1. Type of Well	ell 🔲 Gas/W	ell 🔽 Other Inje	8. Well Name and No. West Blinebry Drinkard Unit (WBDU) #036					
2. Name of Operator Apache Corporation	n (873)			9. API Well No. 30-025-09908				
3a. Address 303 Veterans Airpark Lan Midland, TX 79705	e, Suite 3000		3b. Phone No. (include area code) 432/818-1062		10. Field and Pool or Exploratory Area Eunice; B-T-D, North (22900)

WBDU 36W Proposed Procedure

Deepen Well, Run 4.5" Liner, Re-Perforate and Stimulate

Conditions of Approval

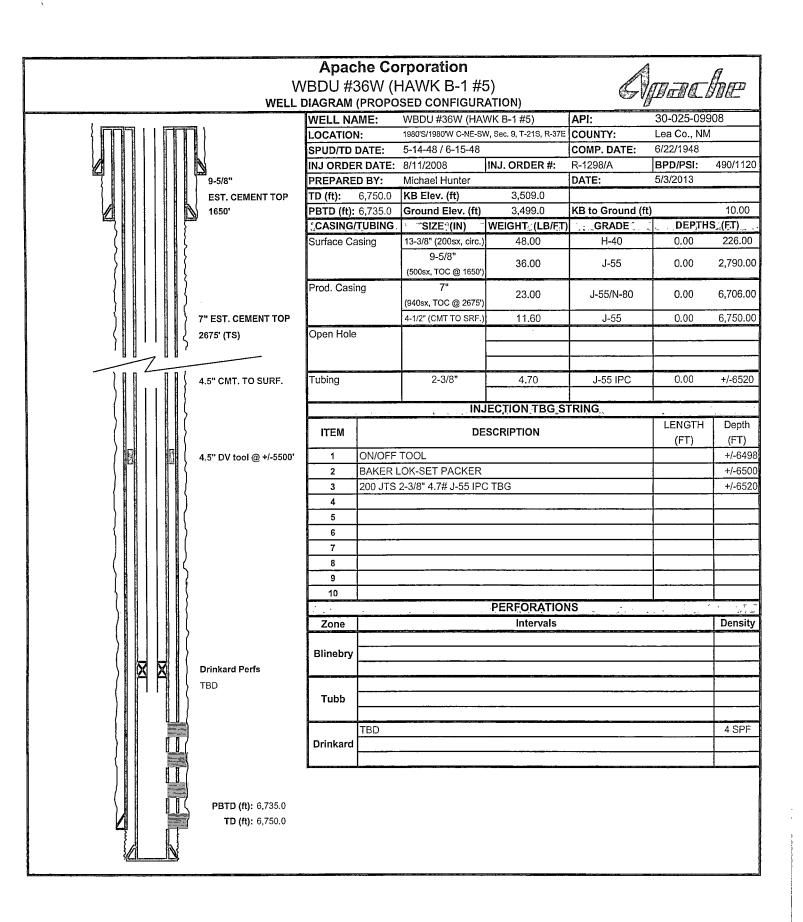
- 8. Subsequent sundry detailing work and current well test data are to be submitted when work is complete.
- 9. Prior to Step 2 of the proposed procedure place cement in the 9 5/8" 7" annulus from the TOC to surface. Expect to circulate cement out the 9 5/8" casing vent.
